# Addendum #2

## Capital Project Committee

Project Name:	Balsam Park Improvements
Bid Number:	FD21-02-034
Date:	March 5, 2021
Project Manager:	Brian Ward

SHEET: **IR-1**

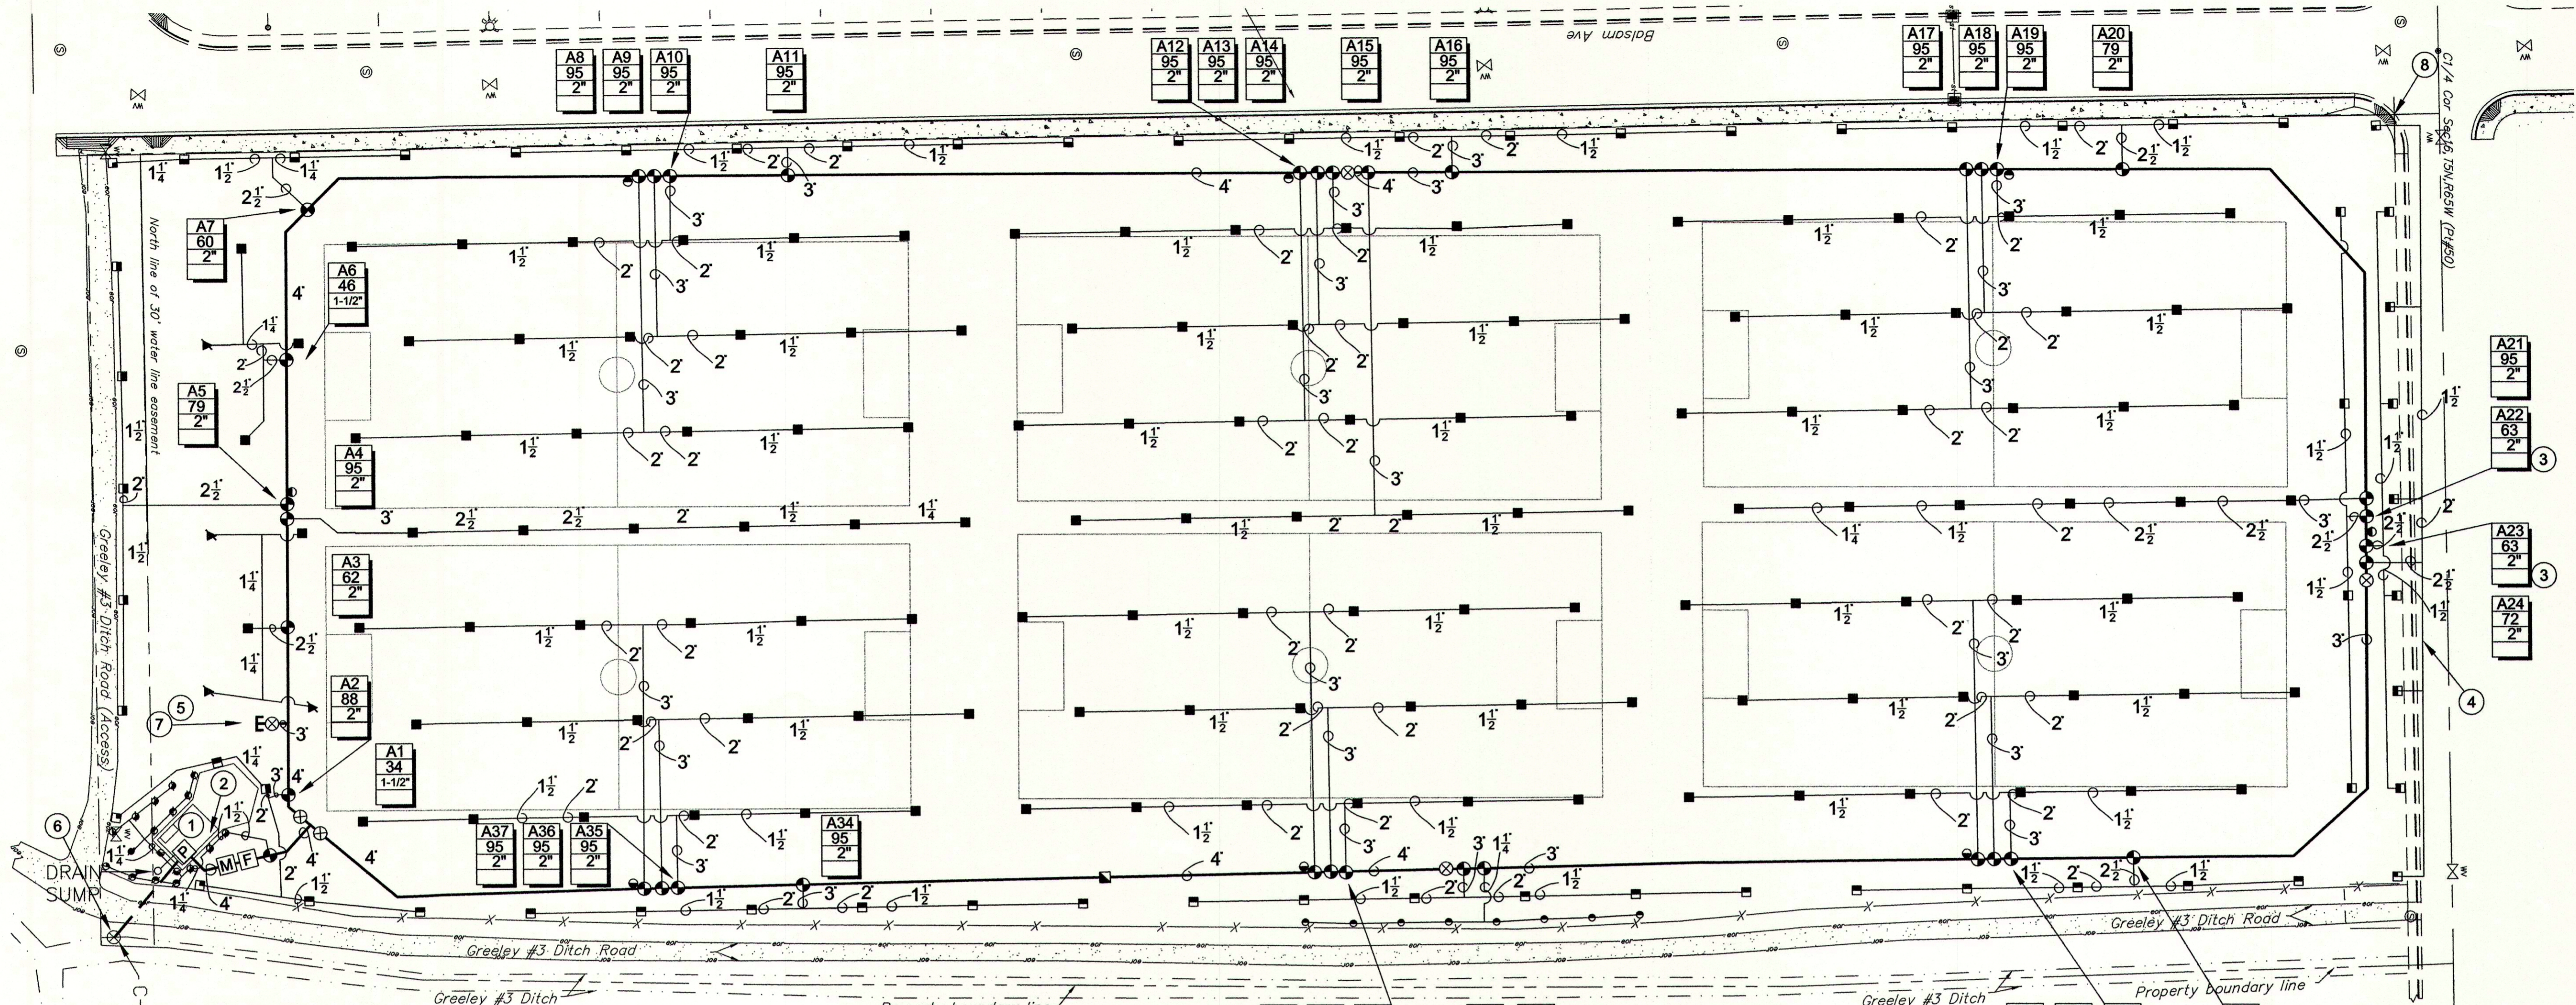
Item 1 Are there any existing irrigation as-builts that can be referenced prior to bidding? If not, please clarify the size of the existing mainline in the designated work area. [Existing mainline is 4". I've attached as-builts for reference.](#)
